ADDENDUM NO. 2

Reference: Building Consolidation – Utah State Hospital
Department of Human Services – Provo, Utah
DFCM Project No. 11065420

Subject: **Addendum No. 2**

C1 BASE @ CLINIC SINK

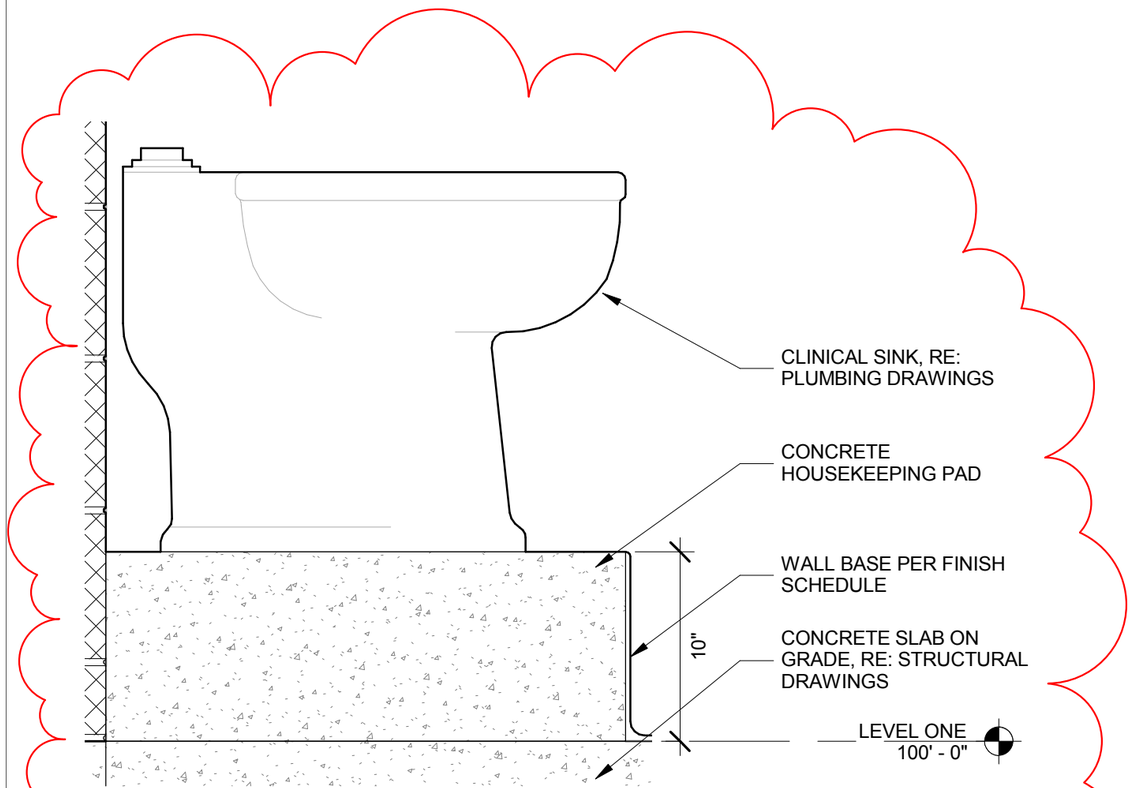
Sheet A560 - Typical Detail
- Added detail C1/A560 Base @ Clinic Sink. See ASD-006

E1 ACCESSIBLE CURB RAMP

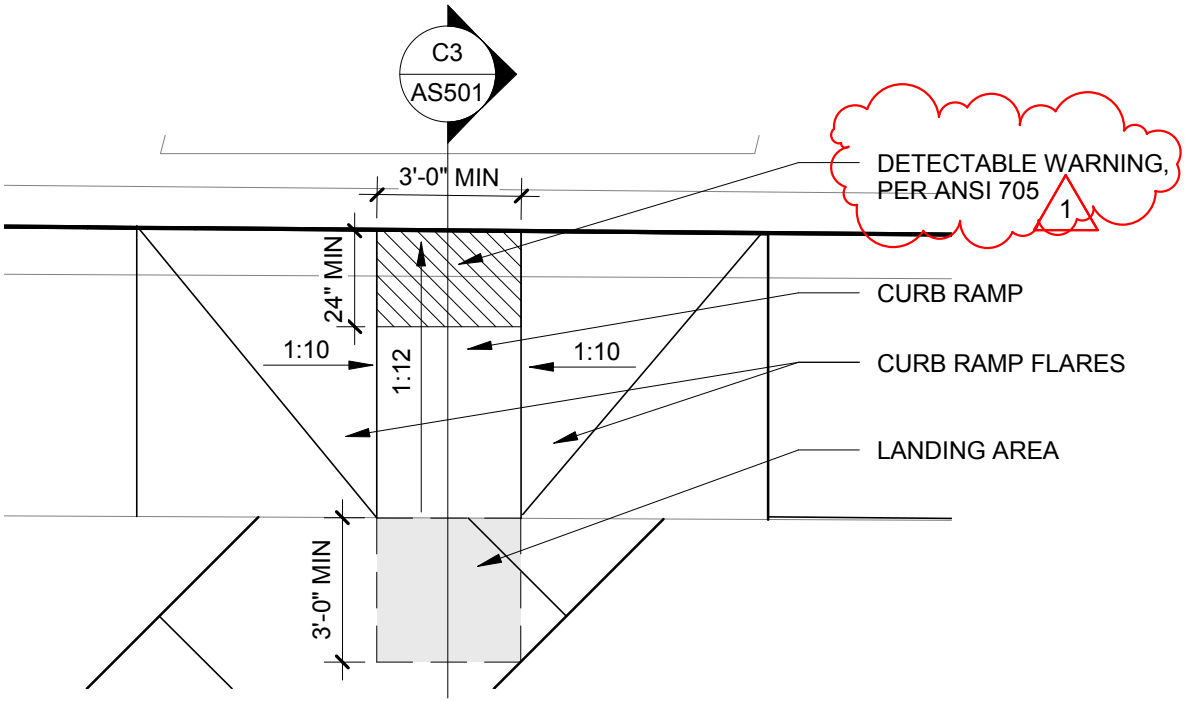
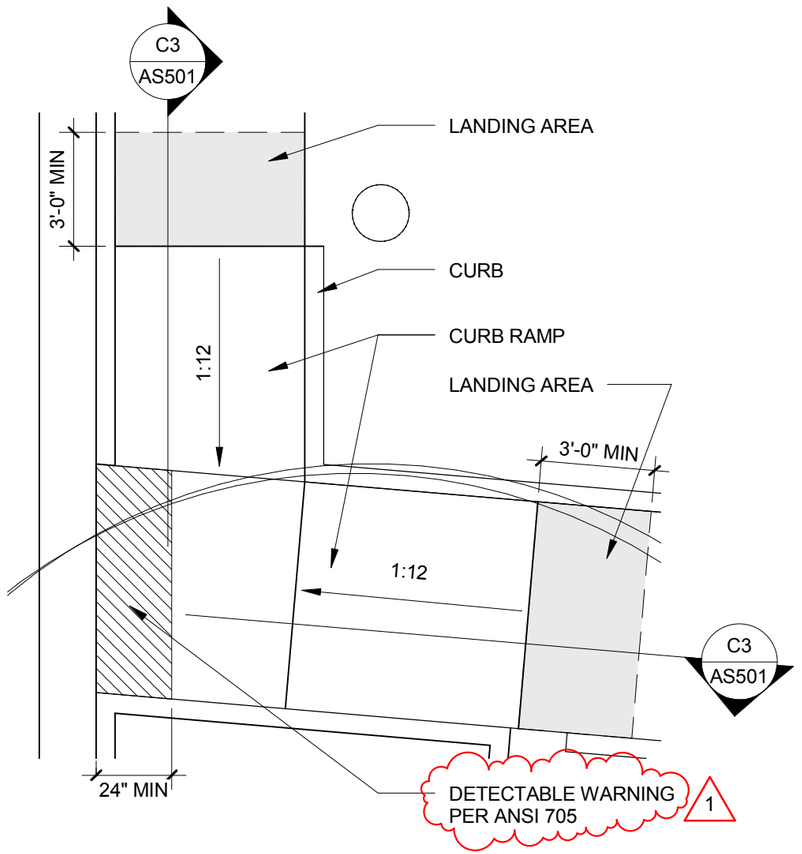
- Modified Details E1, E2, & E3 to add detectable warning at curb ramps

C3 ACCESSIBLE CURB RAMP

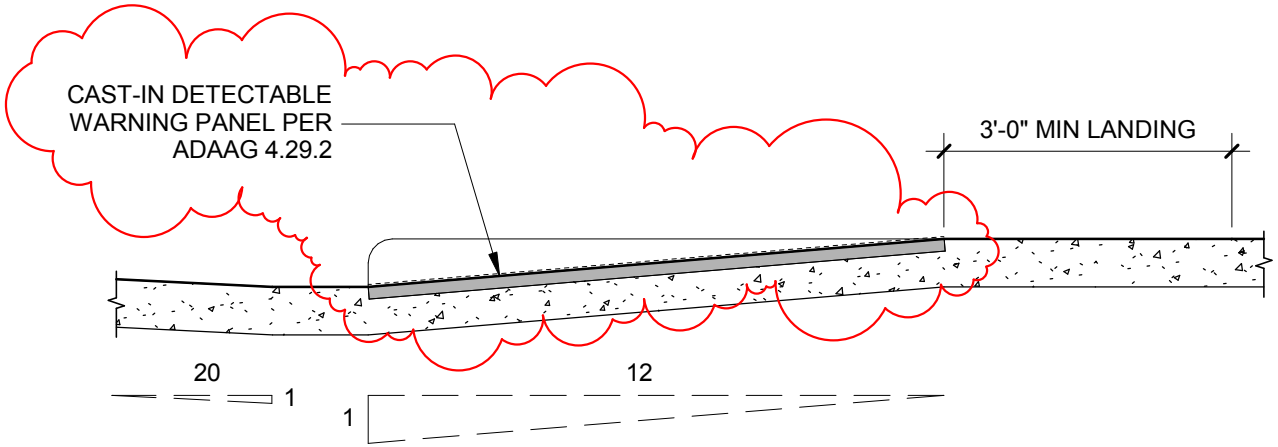
- Added detail C3 Site Bench Section
- Added graphic scales to all details

D1 PARTIAL WEST ELEVATION

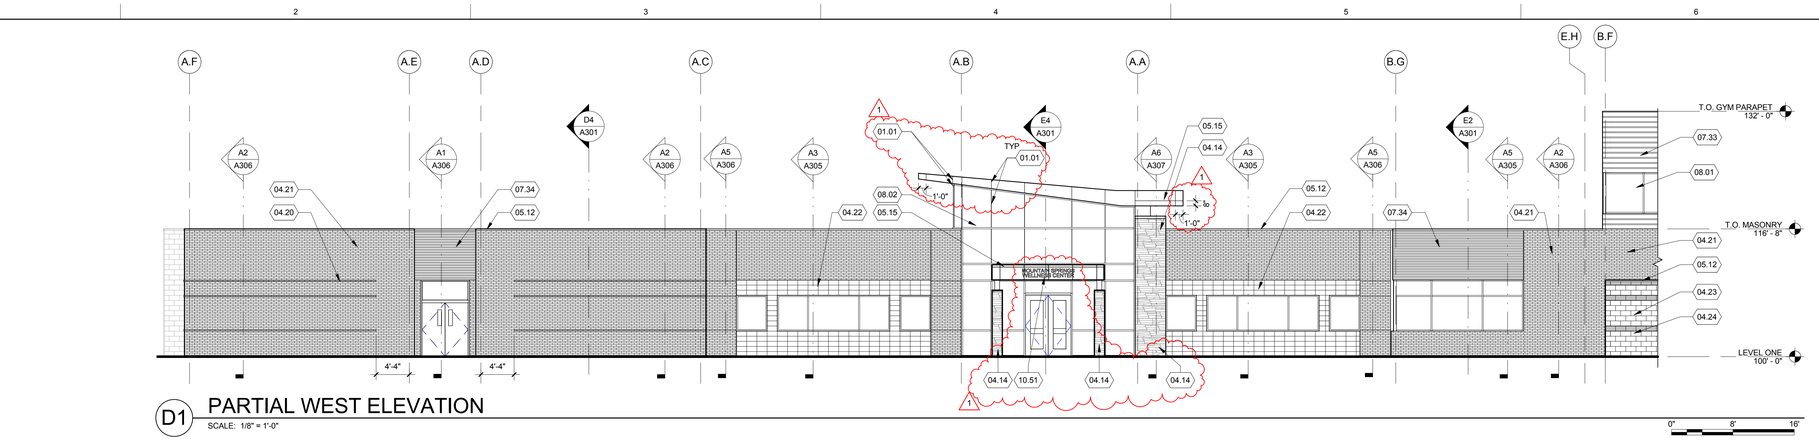
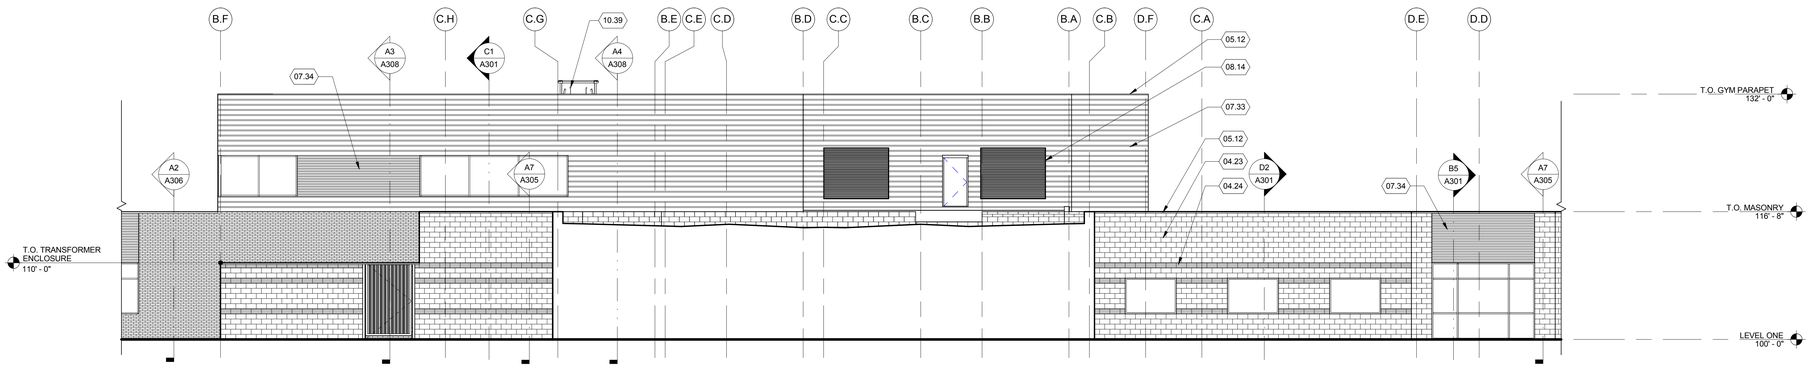
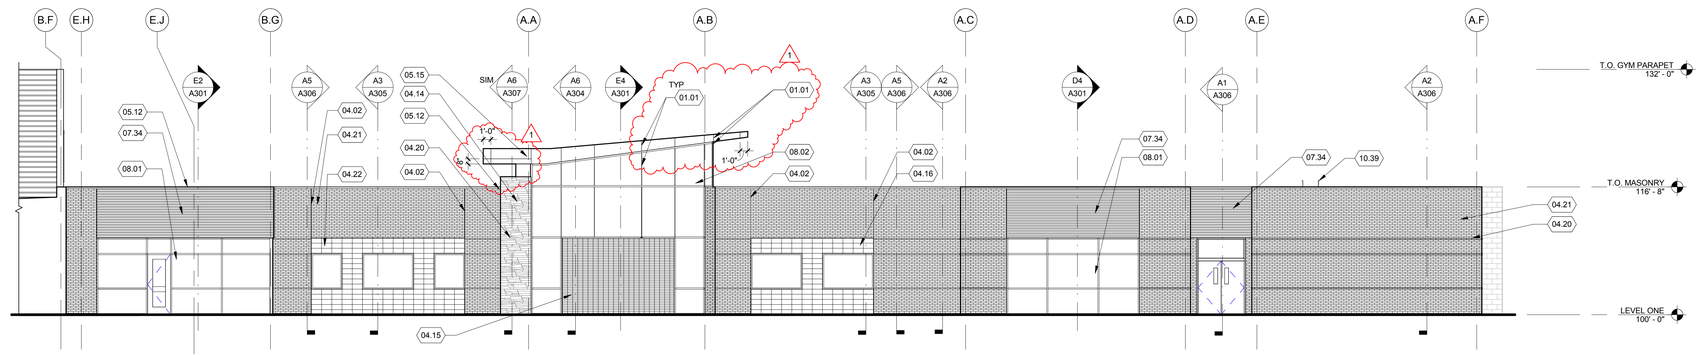
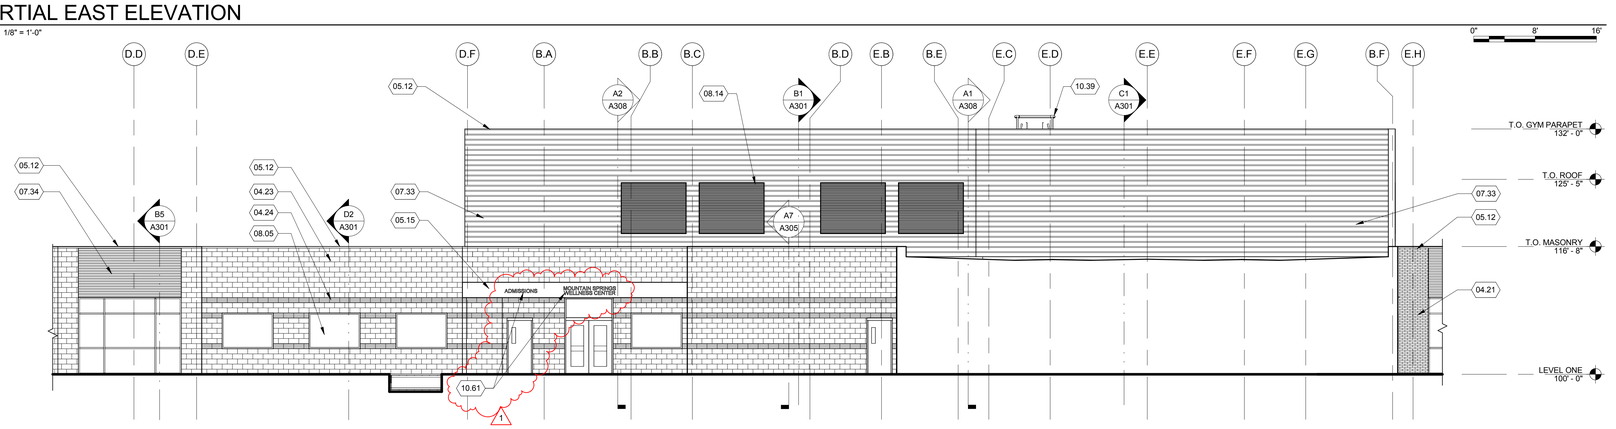
Sheet A201 - Exterior Elevations
- add control joints at Details A1, B2, C2, AND D1
- add Signage detail A1
  See attached.

D1 PARTIAL LOBBY ELEVATION

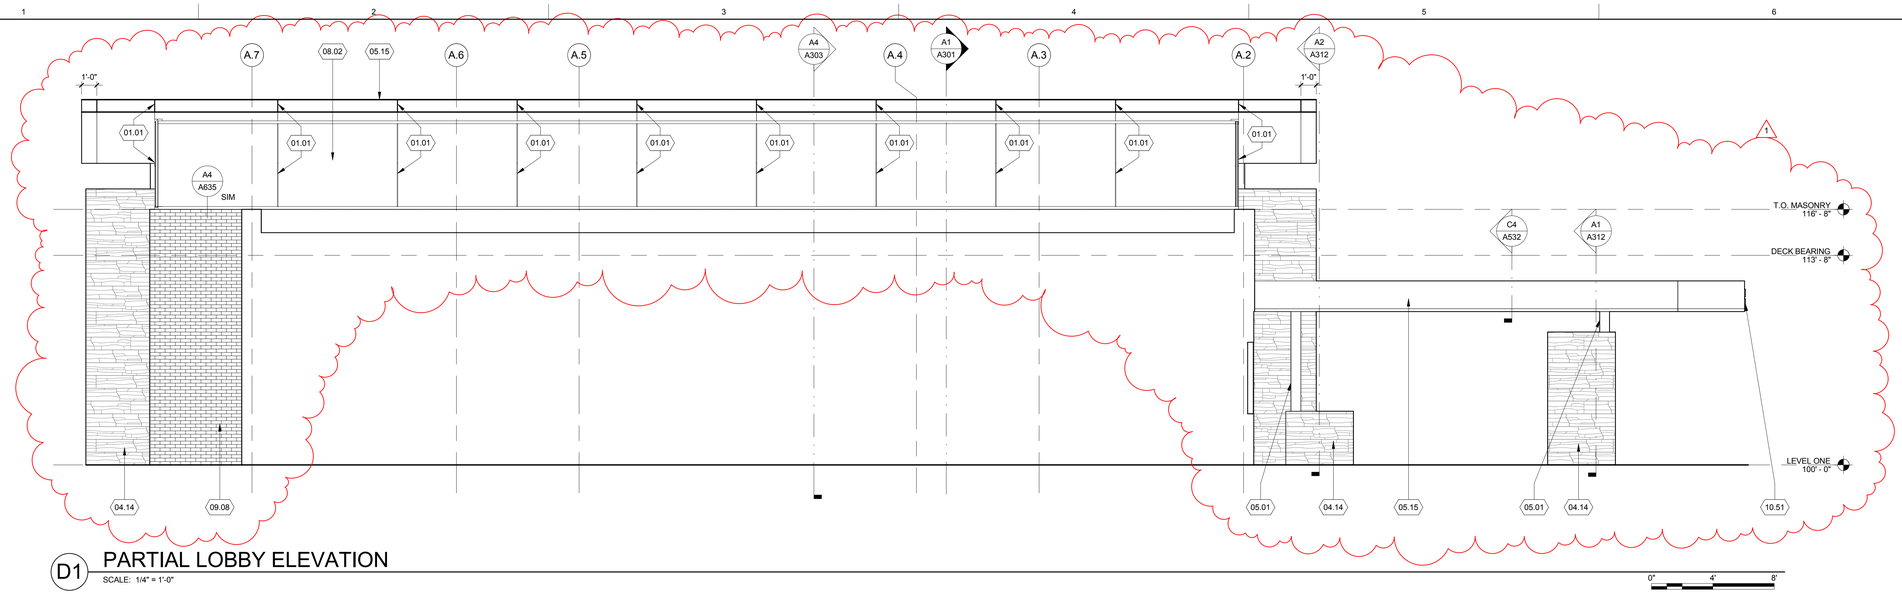
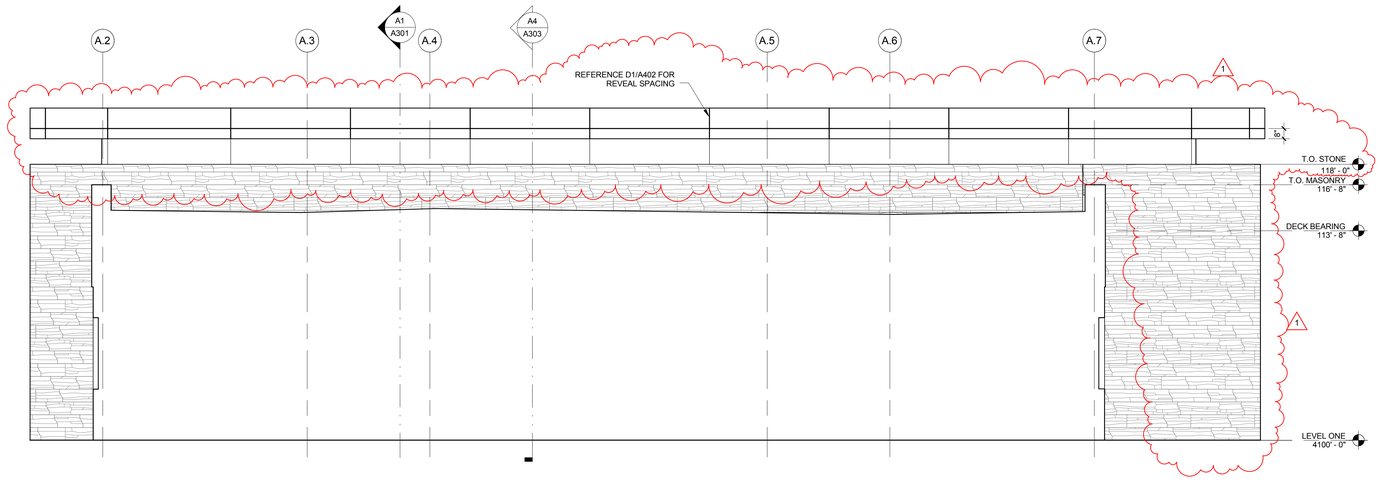
- Hid unnecessary callouts
- Stone wall @ conference was lowered to 18'-0" to match stone wall at entrance
- Reveal pattern revised on details C1 and D1 (sheet rearranged)
